**Environmental Impact Statement
Scoping Process**

Summary Report

**Prairie Island Nuclear Generating
Plant, Units 1 and 2
Red Wing, Minnesota**

**U.S. Nuclear Regulatory Commission
Rockville, Maryland**

Figure 2.

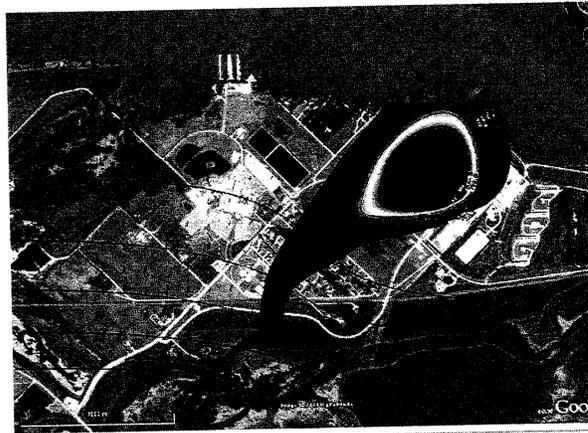
Figure 2, below, represents a simulated groundwater modeling showing the movement of tritium from the PINGP towards the Prairie Island Indian Community. The Community respectfully demands a full and complete disclosure of the monitoring data for all tritium and other radiological contaminants for each well or other monitoring location, and not simply monthly, quarterly or annual averages for individual wells. This data is critical to identify and baseline accidental and planned releases of tritium and other radiological contaminants, and to facilitate the Community's preparation of exposure scenarios, scenario analysis, and computer modeling of all environmental pathways for tritium contamination.

- The higher tritium concentration in onsite wells indicate that PINGP is the tritium source of PIIC wells (see Figure 2);
- No explanation was provided for off-site residence well contamination of tritium since 1989;
